Asphalt Roofing Manufacturing Industry — Background Information for Promulgated Standards

Emission Standards and Engineering Division

U.S. ENVIRONMENTAL PROTECTION AGENCY
Office of Air, Noise, and Radiation
Office of Air Quality Planning and Standards
Research Triangle Park, North Carolina 27711

Figure 3-4. Typical flow sheet for manufacturing shingles and rolls. 12

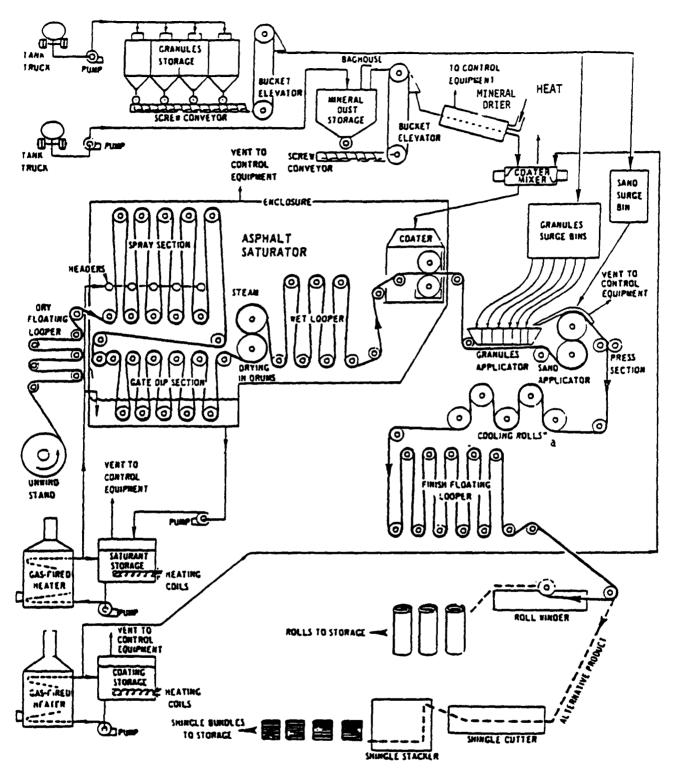
2.15.1.3 <u>Comment</u>. "In Figure 3-4, p. 3-10, there are two errors.

A <u>typical</u> roofing plant does not enclose the coater with the saturator and, to our knowledge, a 'rotary kiln' is no longer used in the industry."

Figure 3-4, p. 3-10, was taken from the second edition of "Air Pollution Engineering Manual." Many coaters are hooded with the emissions ducted to the same control device used for emissions from the saturator. Some of the newer enclosures installed in the industry do cover the coater as well as the saturator. Therefore, we do not consider this to be an error. The corrected figure in Appendix A shows that the mineral particles for coating stabilizer are dried before being introduced into the coating asphalts without specifying the type of drying equipment used to dry the material.

Figure 3-4 has been changed to remove the rotary kiln for drying mineral dust and to substitute a mineral dryer for this process.
